Adamstown Station District Centre, Co Dublin  
Masterplan - Phase II - Block G

Application for Amendments to Block G  
REQUEST FOR FURTHER INFORMATION | FEBRUARY 2022

REQUEST FOR FURTHER INFORMATION

**CLIENT:** QUINCY BELAND LTD.  
**PROJECT:** ADAMSTOWN STATION BLOCK 6  
**GENERAL ARRANGEMENT - LEVEL 16 - NORTH-FLOOR PLAN**

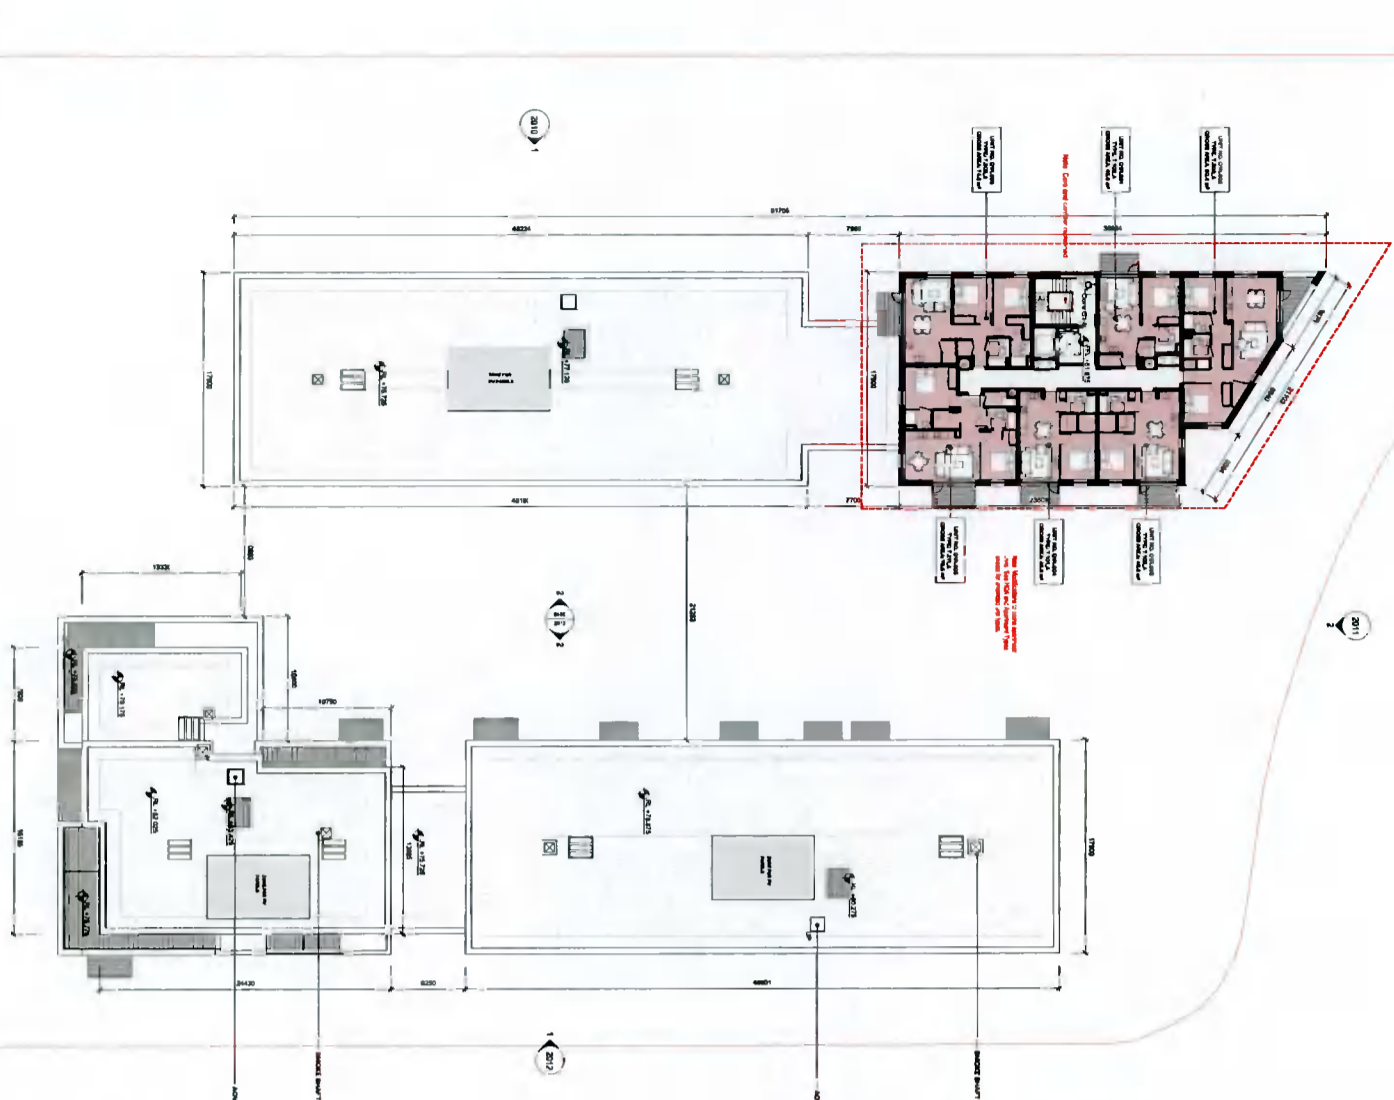
**RFI no. 1. (a)**

- Major Modifications:**  
 Removal of corridor access to podium on first floor and adjustments in size and shape of other residential Units
- Minor Modifications:**  
 Minor adjustments to unit layouts and areas pertaining mostly to unit layout widths or lengths reset due to a modified structural grid
- RFI no. 1. (d)**  
 A Residential Unit introduced

**CLIENT:** QUINCY BELAND LTD.  
**PROJECT:** ADAMSTOWN STATION BLOCK 6  
**GENERAL ARRANGEMENT - LEVEL 16 - NORTH-FLOOR PLAN**

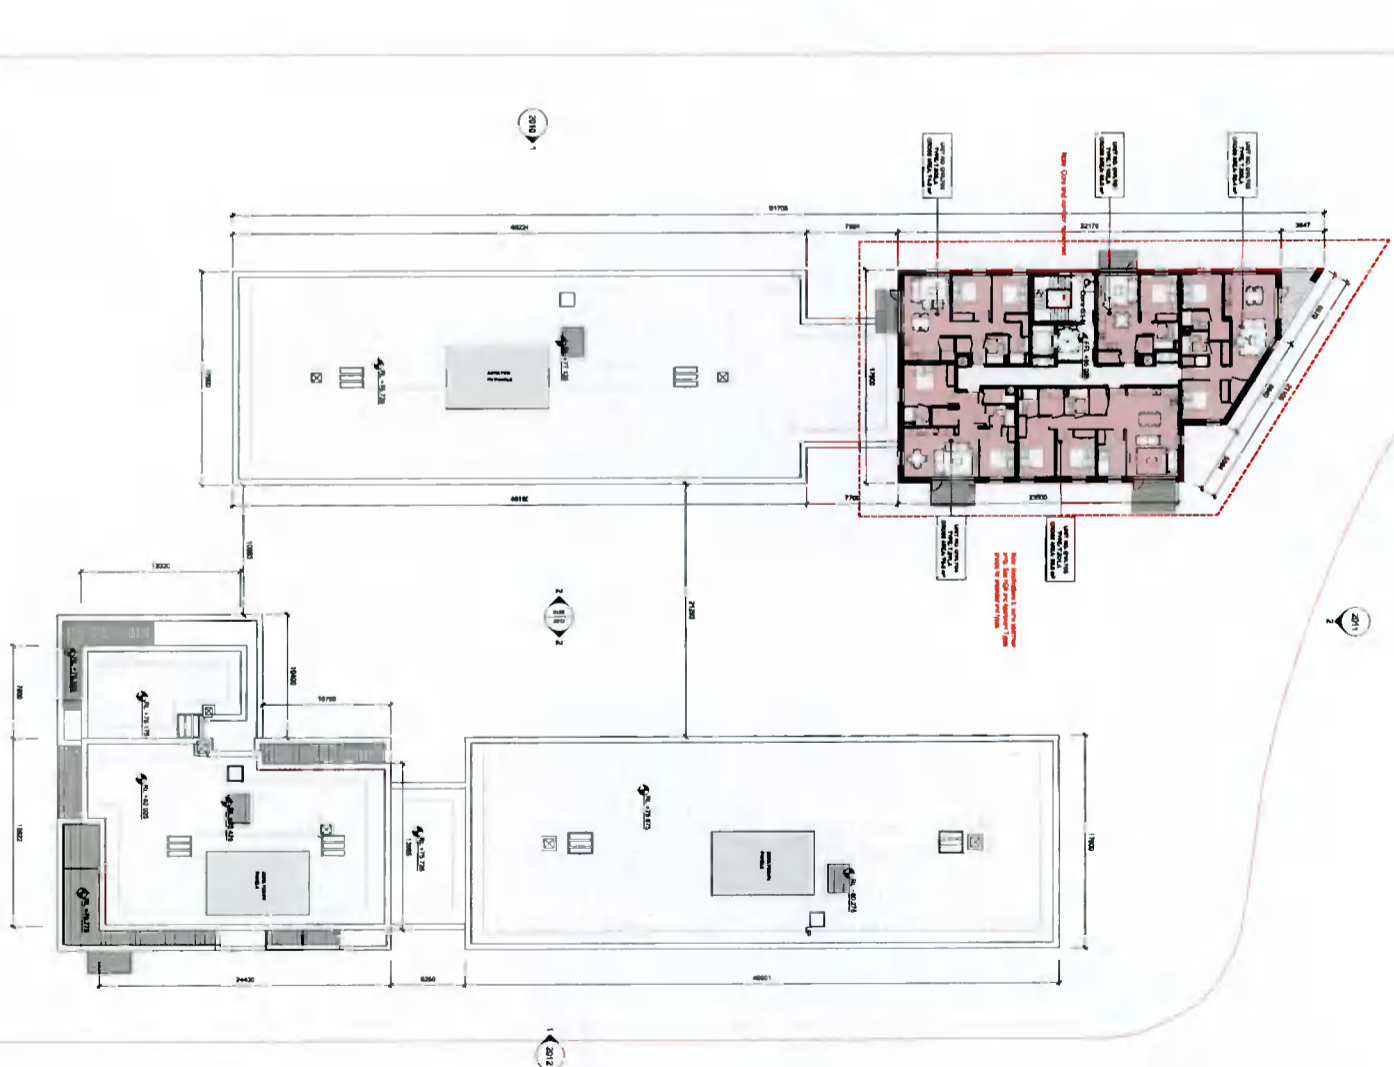
**RFI no. 1. (a)**

- Major Modifications:**  
 Removal of corridor access to podium on first floor and adjustments in size and shape of other residential Units
- Minor Modifications:**  
 Minor adjustments to unit layouts and areas pertaining mostly to unit layout widths or lengths reset due to a modified structural grid
- RFI no. 1. (d)**  
 A Residential Unit introduced

CLIENT	QUINTAIN IRELAND LTD.
PROJECT	ADAMSTOWN STATION BLOCK G
DRAWING	BLOCK G - GENERAL ARRANGEMENT - NORTH & SOUTH ELEVATIONS
PROJECT NUMBER	130621
SCALE	As detailed
DRAWN	MJ
CHECKED	ML
DATE	13/06/21
STATUS	FOR FURTHER INFORMATION
DRAWING NUMBER	ACC-HUL-G-ZZ-DR-A-2011
REVISION	P04

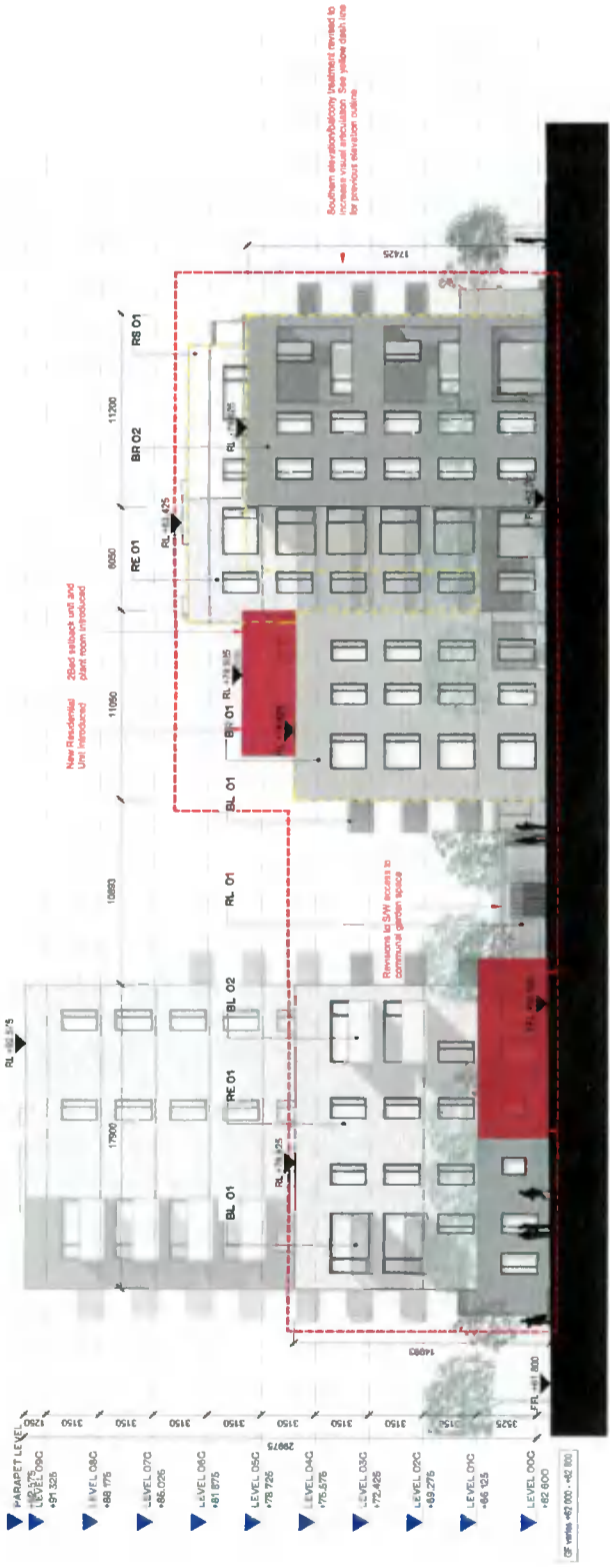
RFI no. 1. (d)

A Residential Unit introduced

1 GA - ELEVATION - EAST - G2 - PLANNING  
 1 : 200

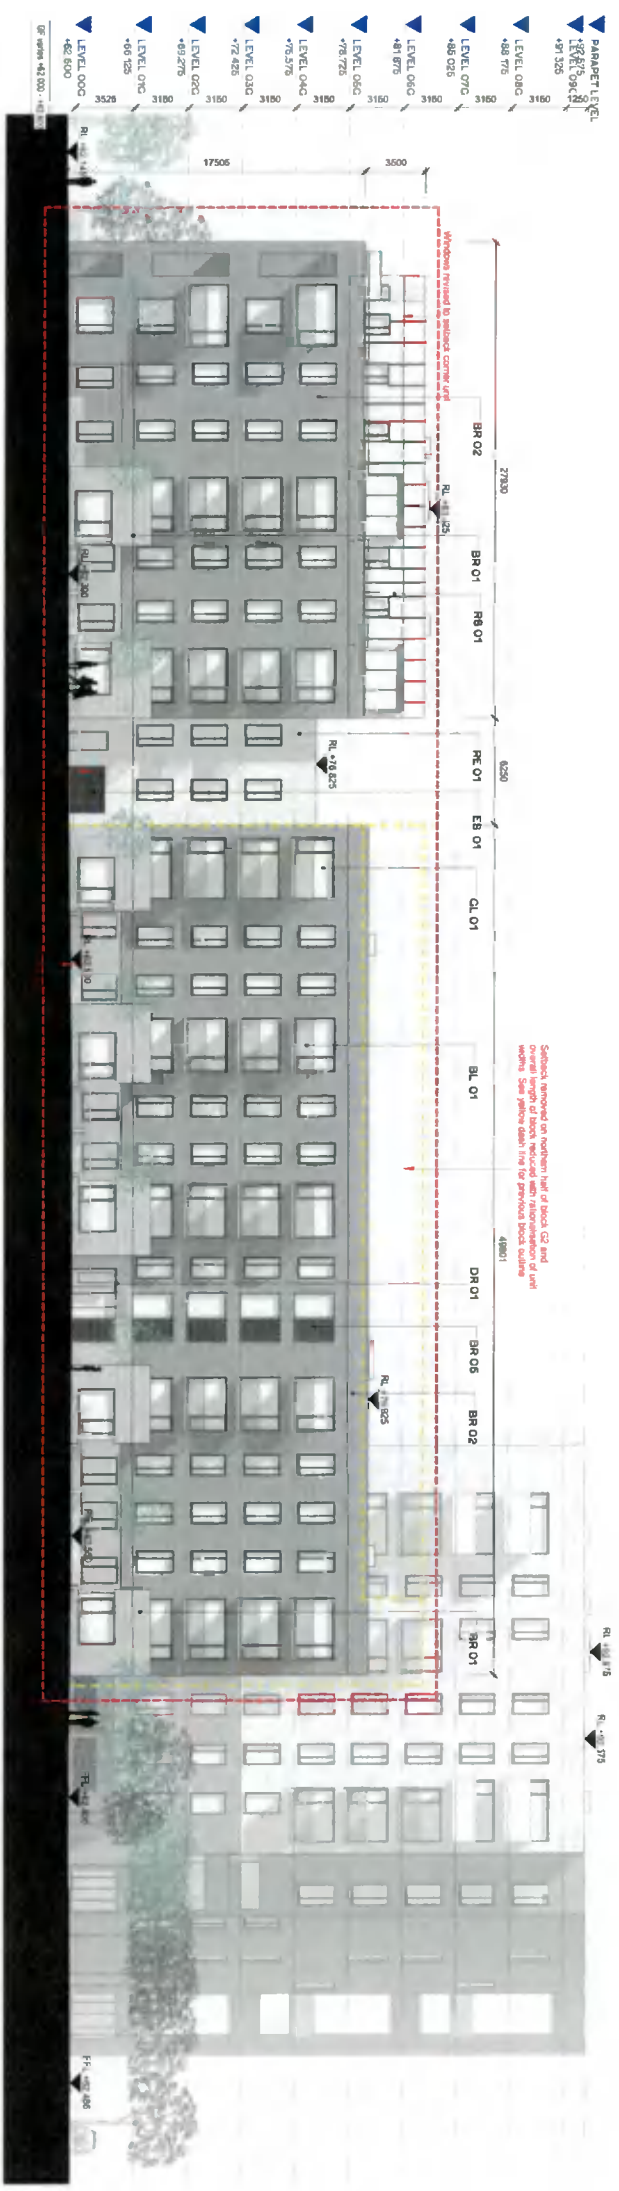
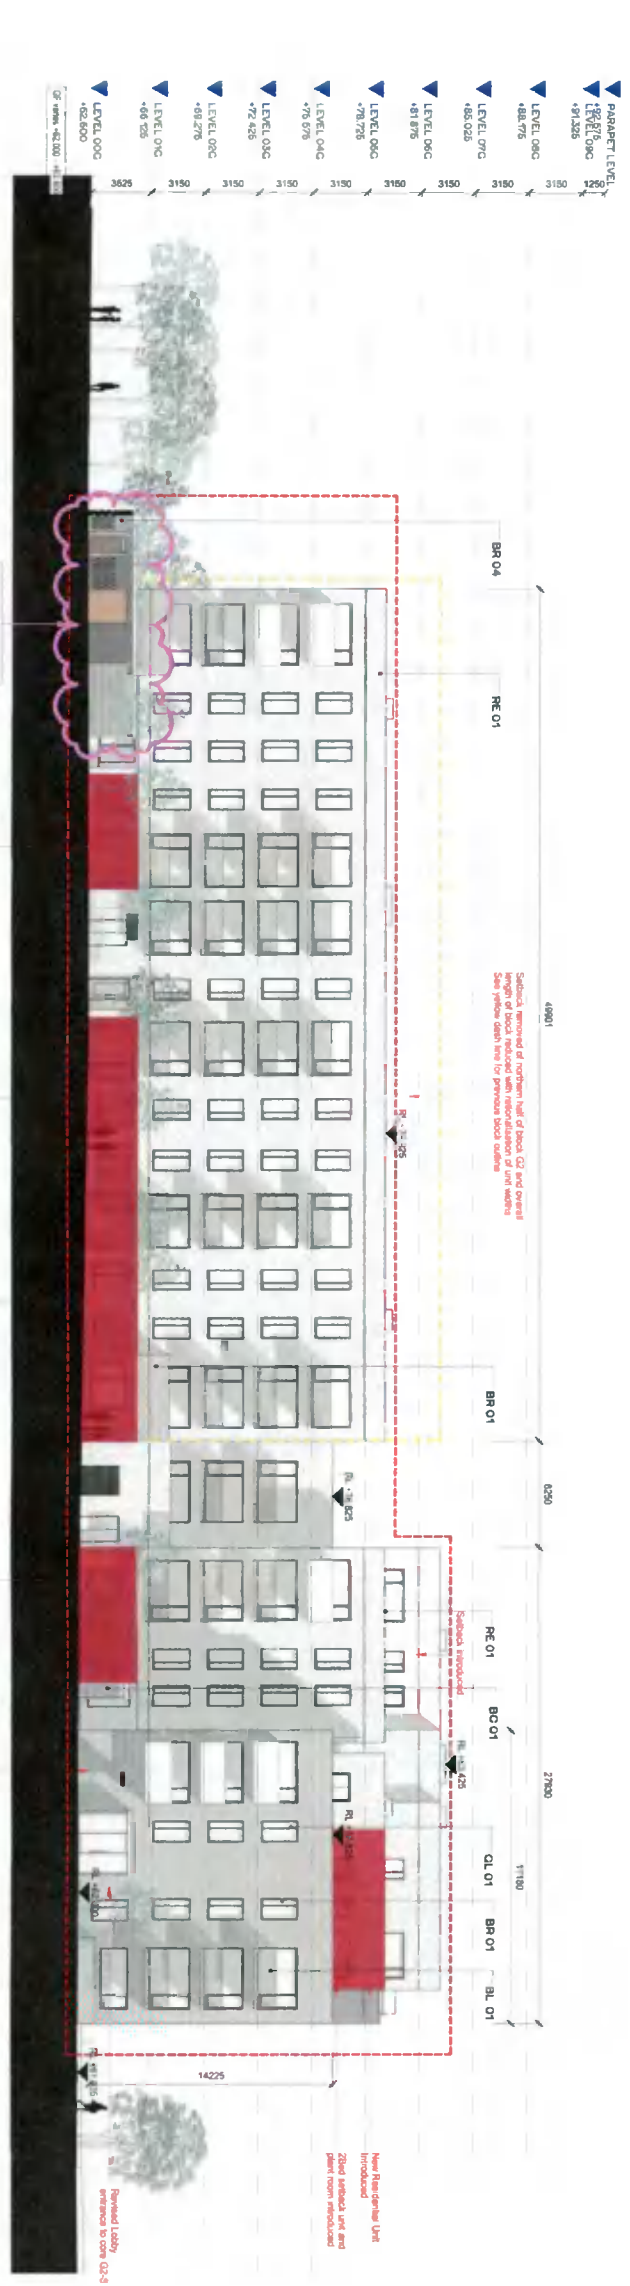
**RFI no. 1. (d)**  
 A Residential Unit  
 Introduced

**RFI no. 4.**

New Residential Unit Introduced

CLIENT	QUINTAIN IRELAND LTD.
PROJECT	ADAMSTOWN STATION BLOCK G
DRAWING	OPEN SPACE SCHEDULE
PROJECT NUMBER	AD-CHL-G-ZZ-DR-A-1930
DATE	19/01/2020
DRAWN/CHECKED	KL/DB
REVISION	P04

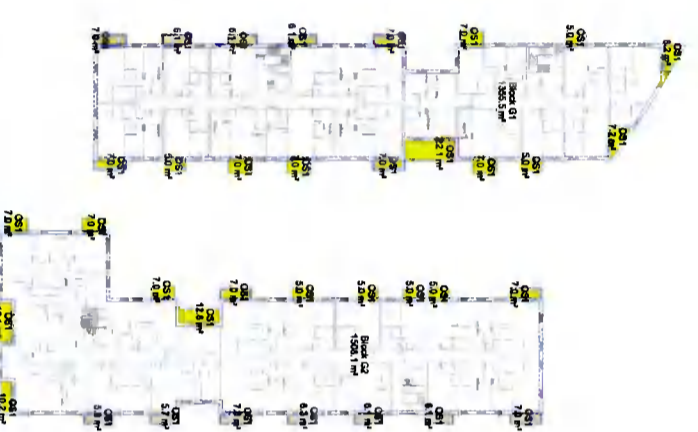
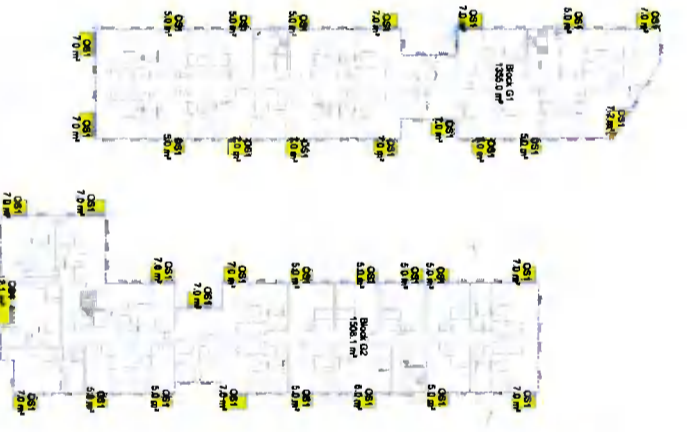
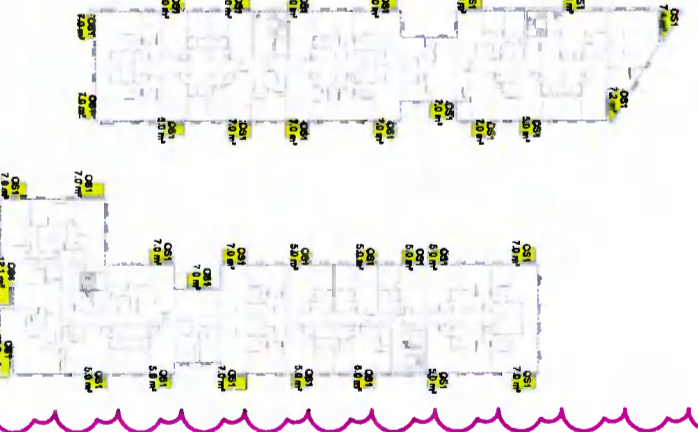
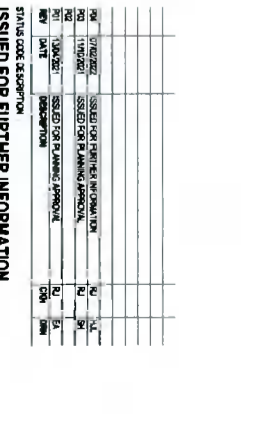
1. (b) *The applicant has submitted a 'Quality Housing Assessment' which indicates that all apartments meet the requirements in terms of kitchen/living area, aggregate bedroom area, storage and private amenity. However, this is contrary to drawing ADC-HJL-G-ZZ-DR-A-1950 (Rev P03) Open Space Schedule, which indicates that less than 5sq.m private amenity would be provided in some instances. The applicant is requested to confirm whether the requirements would be met in all instances or whether there would be deviations from this.*

Drawing ADC-HJL-G-ZZ-DR-A-195 (Rev P03) Open Space Schedule has been corrected.

No less than the minimum required private amenity space is provided for all residential units within Block G.

RFI no. 1 (b)  
 Full compliance with minimum private open space area requirements
